CITY OF ALBUQUERQUE

RE: **Lot 20 Block 5 S.A.D. 227 Unit 5**
7940 Victoria Dr. NW
Grading and Drainage Plan
Engineers Stamp Date 12/31/19 (E10D075)

DRAINAGE AND TRANSPORTATION INFORMATION SHEET (REV 6/2018)

ENGINEER'S SEAL	LOT 20 BLK 5 UN 2 VOL. CLIFFS SUB. 7940 VICTORIA DRIVE NW	DRAWN BY DEM
	GRADING AND DRAINAGE PLAN	DATE 12-31-19
12/31/19	 1608 CENTRAL AVENUE SE SUITE 201 ALBUQUERQUE, NM 87106 (505) 972-0899	7920 VICTORIA DRIVE NW.DWG
DAVID SOULE P.E. #14522		SHEET # C1
		JOB #

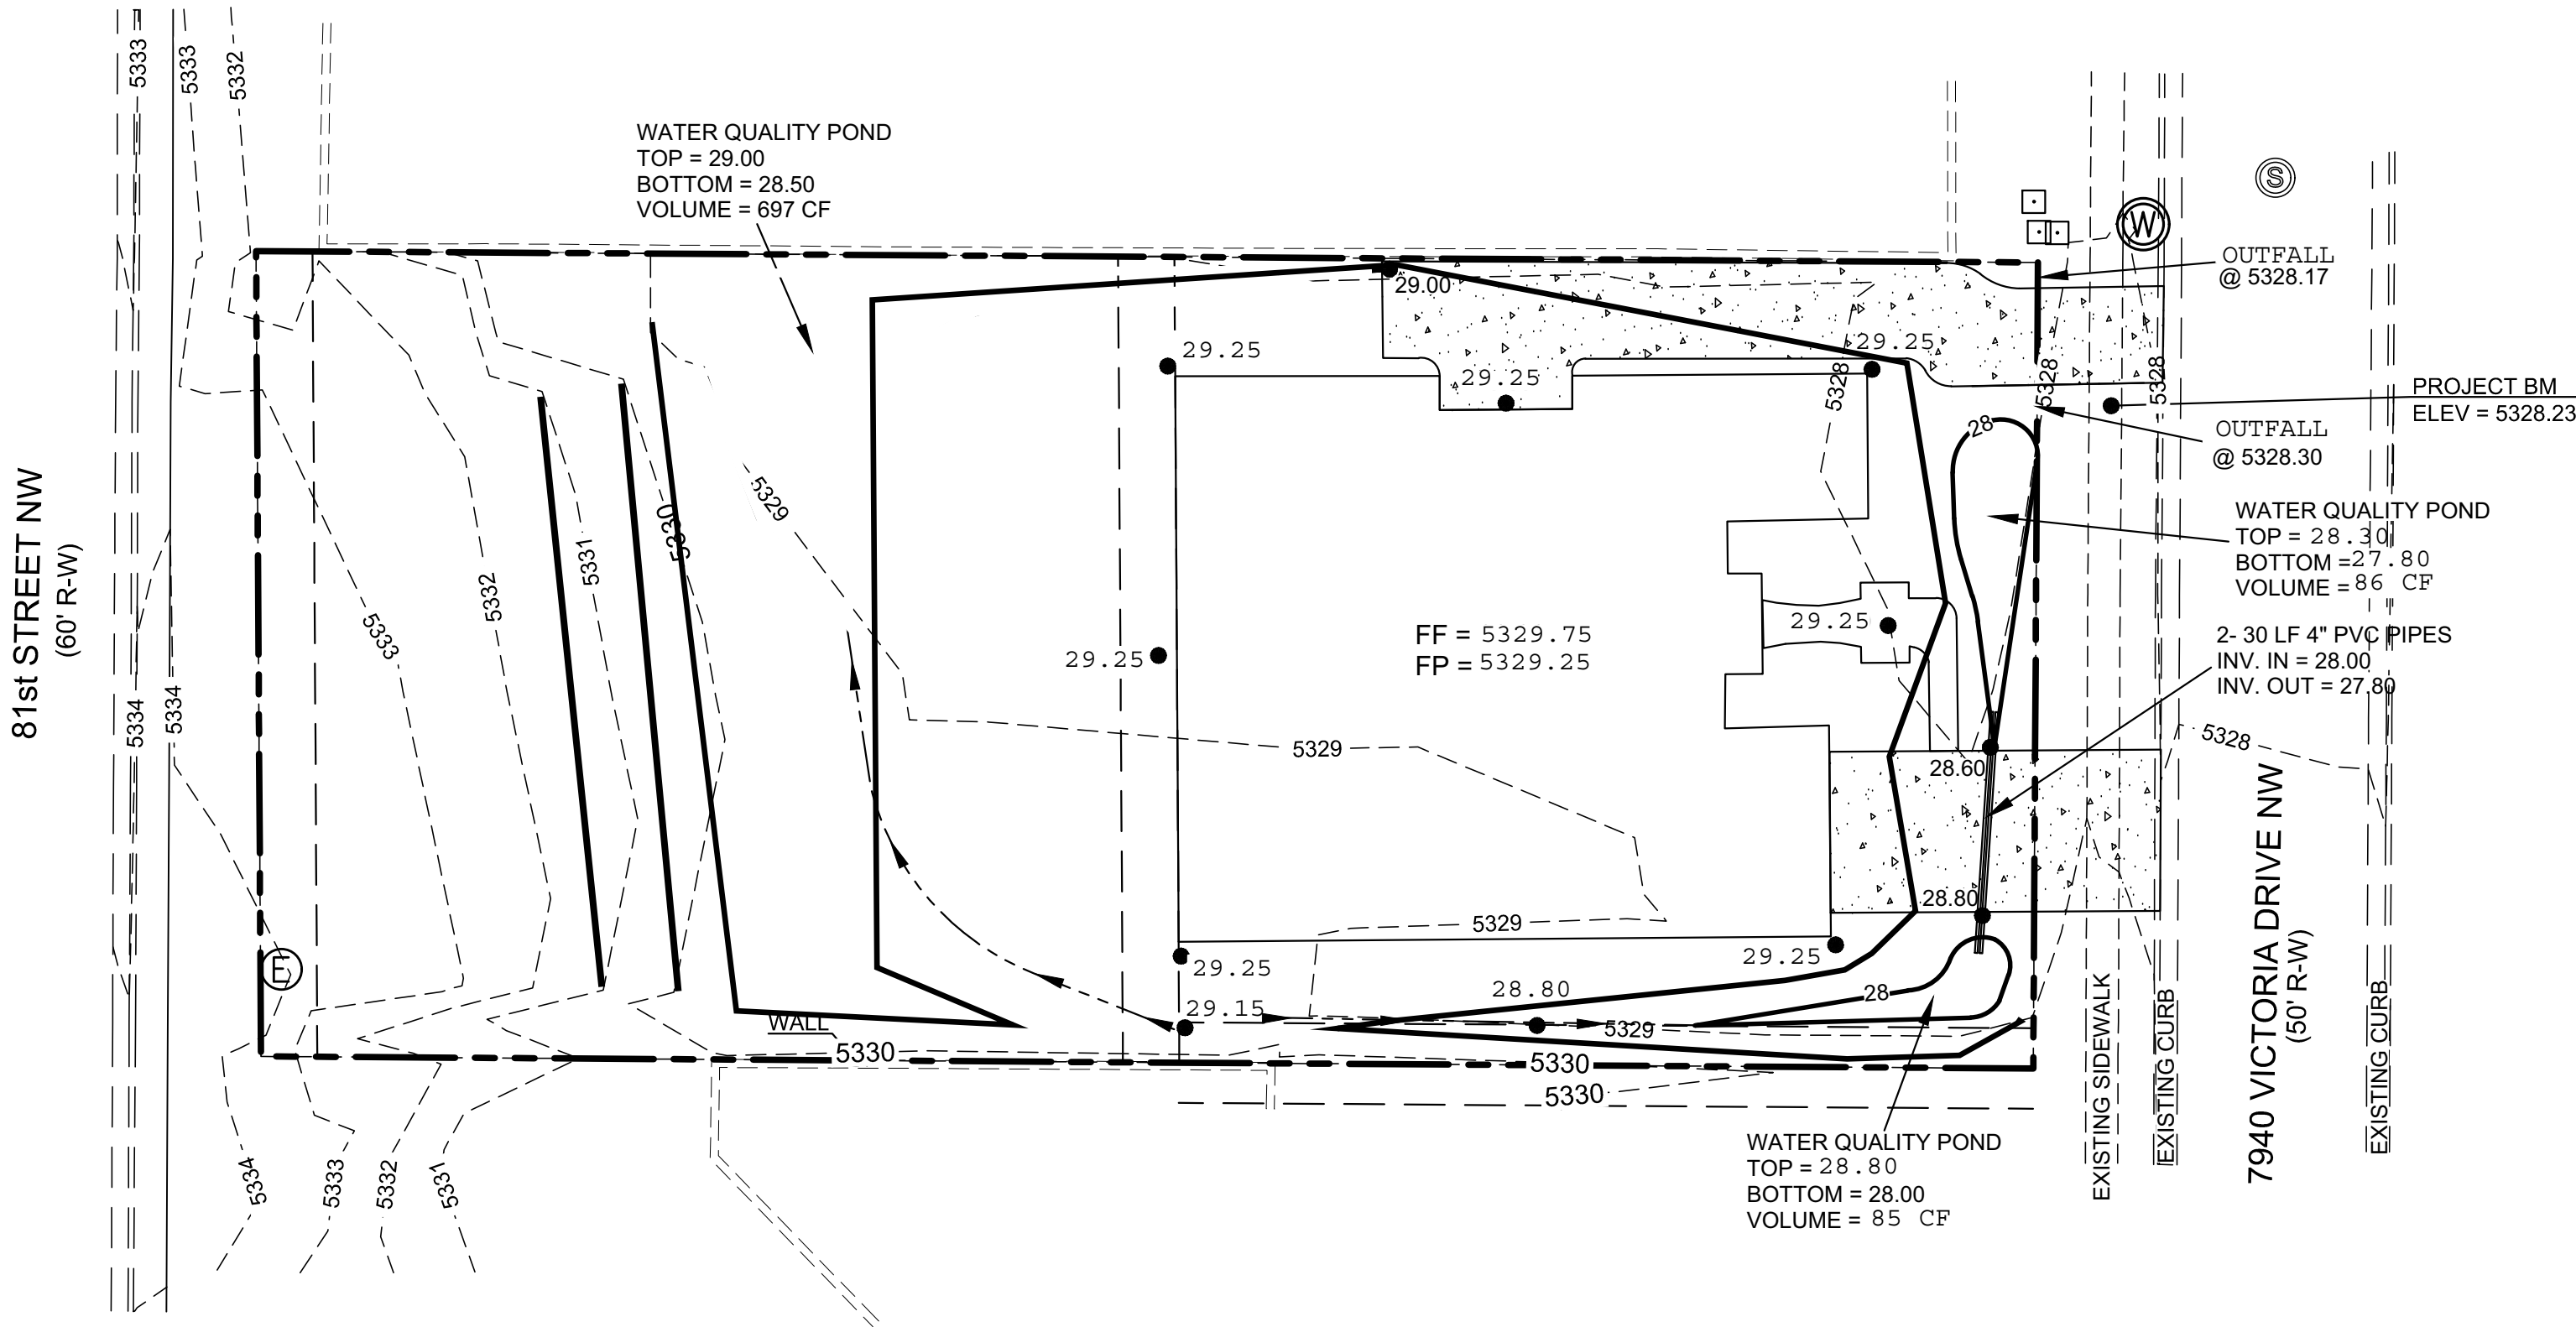
Based upon the information provided in your submittal received 12/31/19, this plan is approved for Grading Permit. Please inform the builder/owner to attach a copy of this approved plan and letter into the construction sets in the permitting process prior to sign-off by Hydrology.

Reiterate to the Owner/Contractor that a separate permit for any garden/retaining wall must be obtained, with the approved G&D plan.

Prior to Building Permit approval, a **Pad Certification** will be required. Inform the contractor/owner not to pile dirt in the street as a ramp to climb the curb. If dirt is found in the street the pad cert. will be denied.

Prior to **Certificate of Occupancy release**, Engineer Certification per the DPM checklist of this plan will be required.
